Plan Set (15 sheets)  
for PB Hearing  
April 8, 2008

# Subdivision Application

## Morningstar Lane

Summit Street  
Portland, Maine 04101

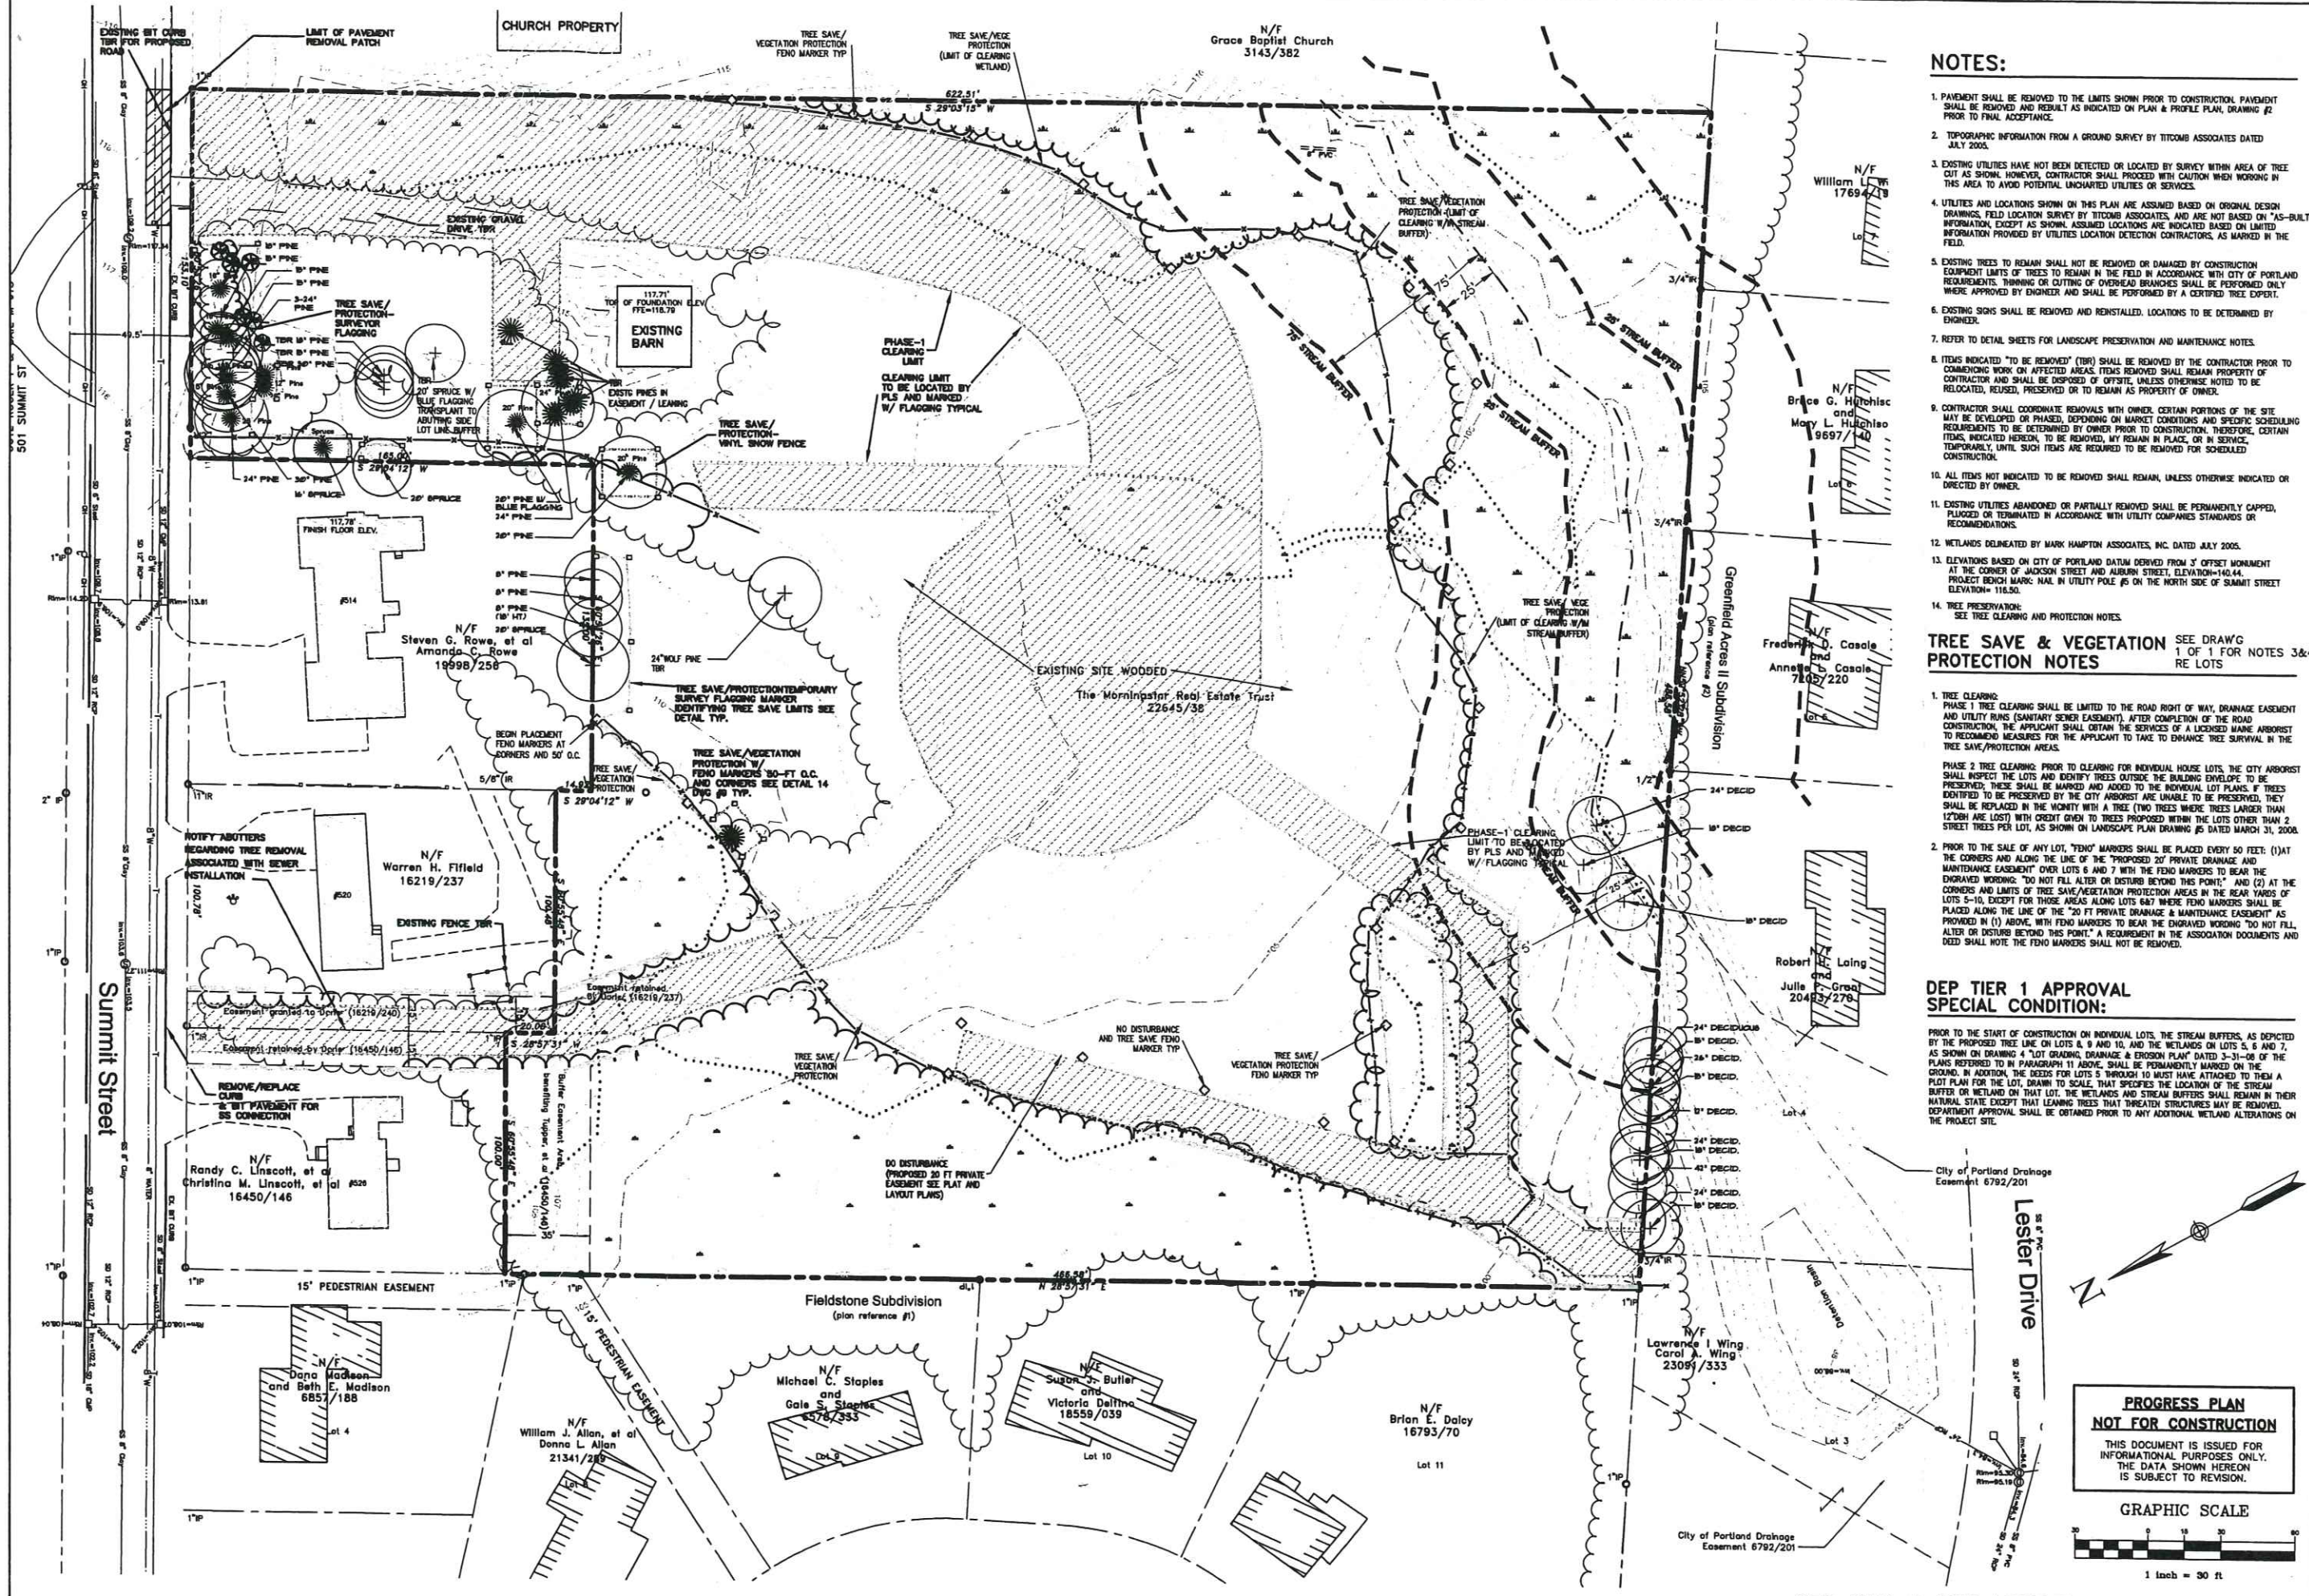
*The trees discussed and flagged with blue tape have been field located by triangulation with the proposed access road centerline staking and from property boundaries. This information is shown on Drawing #1 Existing Conditions and Removals and on Drawing #5 Landscape Plan.*

The tree locations have been added to the Drawing 1, Existing Conditions and Removals and Drawing 5, Landscape.

FIGURE #: 4.1

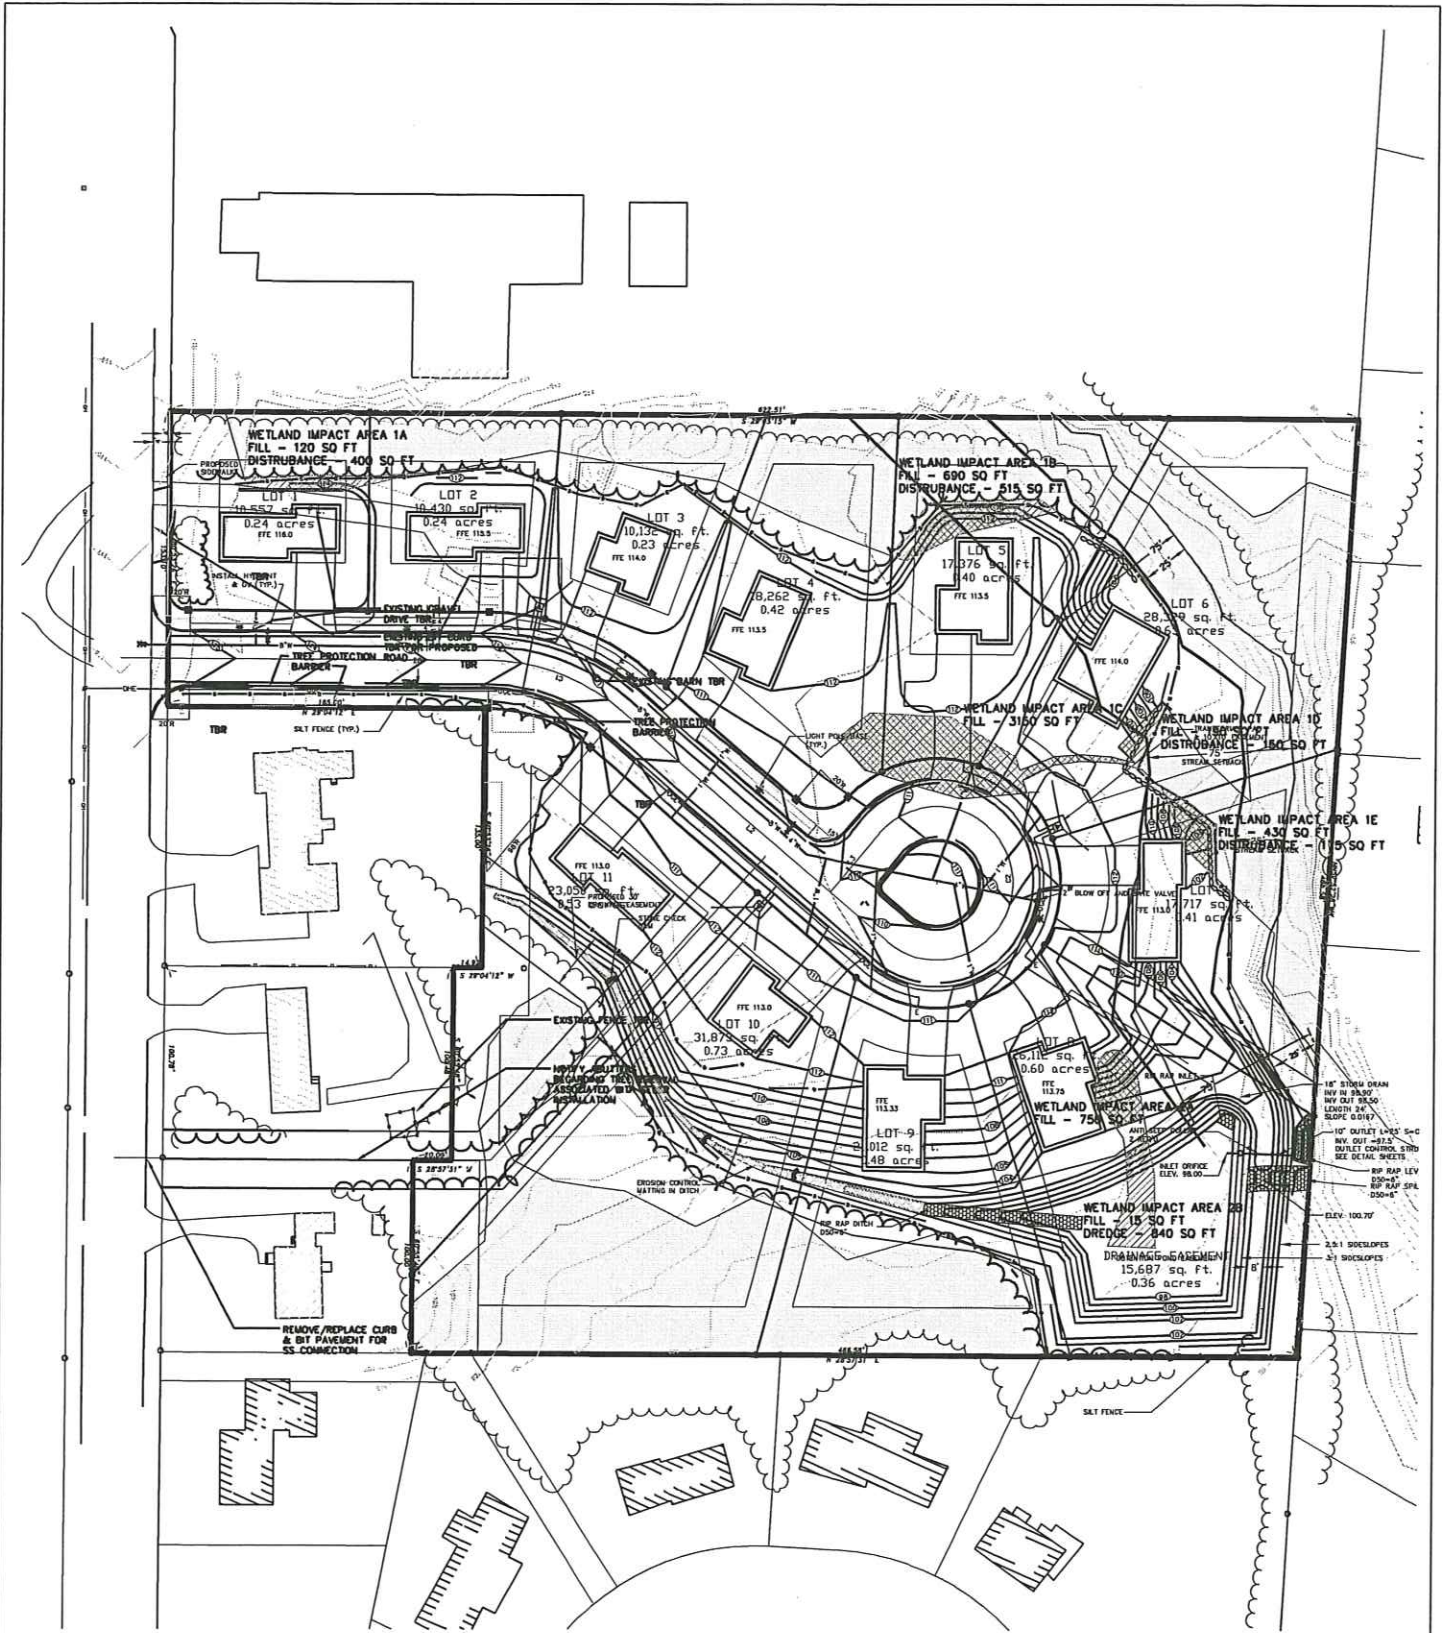
*The areas of wetland fills are shown on the attached Exhibit 4.1. The updated NRPA Permit Application will be copied to the Planning Dept. when it is re-submitted to the DEP.*
